**Monks Orchard Residents' Association  
Planning**

Town and Country Planning Act 1990. Appeal under Section 78. Planning Appeal (W)

Location: 211 Wickham Road  
Application Number: 21/00222/FUL  
Appeal Reference: APP/L5240/W/21/3279454  
Case Officer: Milena Opolska  
Start Date: 19 Jan 2022  
Consultation close: 23 Feb 2022

Please accept this formal letter supporting the LPA refusal of the proposed development **Ref: 21/00222/FUL** as our written Statement for request for **Dismissal** of the **Appeal Ref: APP/L5240/W/21/3279454** against the LPA's refusal for: *"Demolition of the existing outbuildings to the rear of the shop and erection of a two-storey building containing four flats, with car parking and other associated alterations"*

**Graphical illustration of Site Capacity for 0.03 ha Housing Density in**

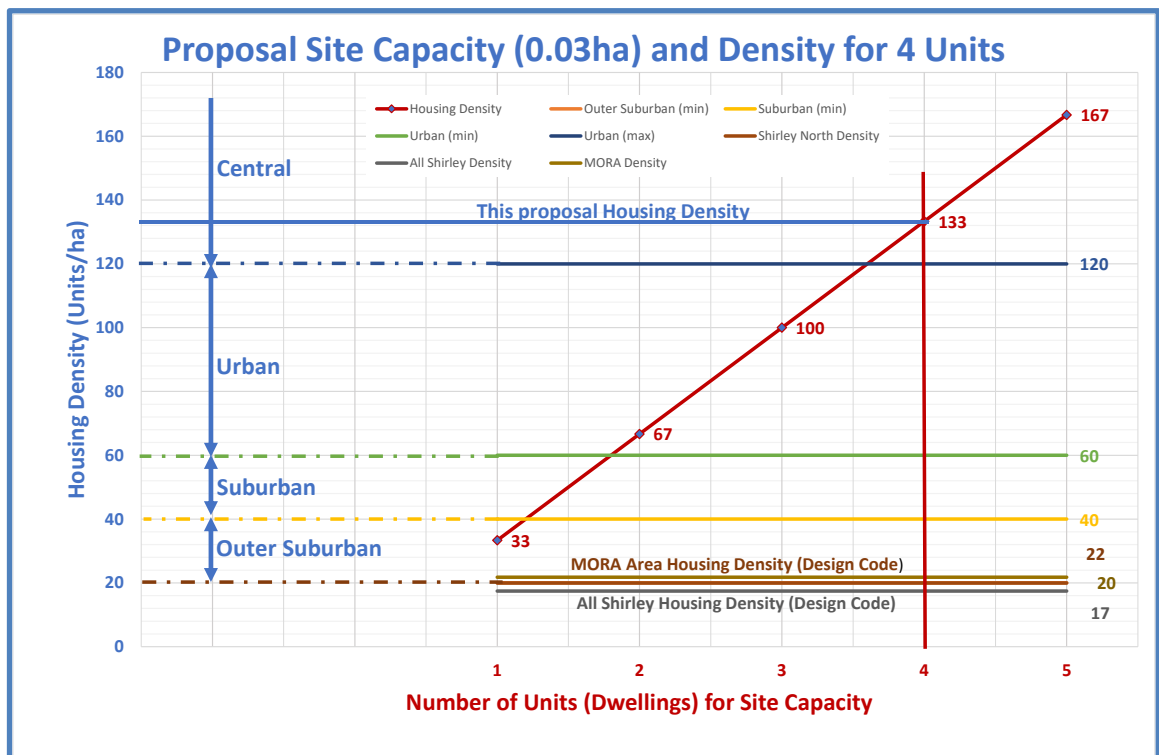
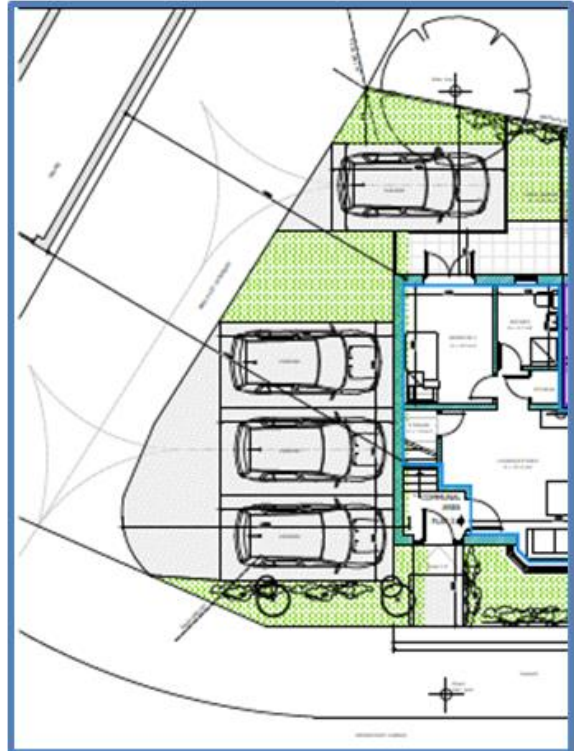
- 3.2.5 The proposal is for **4 dwellings** on a **Site Area of 0.03ha** which equates to a Housing Density of **133.33 dwellings/ha**. This would require the **Setting** to be **Central** as defined by the **National Model Design Code and Guidance<sup>2</sup>**. Shirley is **clearly NOT** a '**Central**' **Setting** as shown by all the analysed evidence of the local area assessment at the Table shown at 3.2.3 above.

- 3.2.6 The graphical illustration above clearly demonstrates that the proposal for 4 dwellings on the proposed Site Capacity at this Housing Density would require a "**Central**" **Setting** and is clearly a significant over development for an **Outer Suburban Setting**. **This supports the LPA's Refusal on grounds of excessive scale and overdevelopment for the locality.**
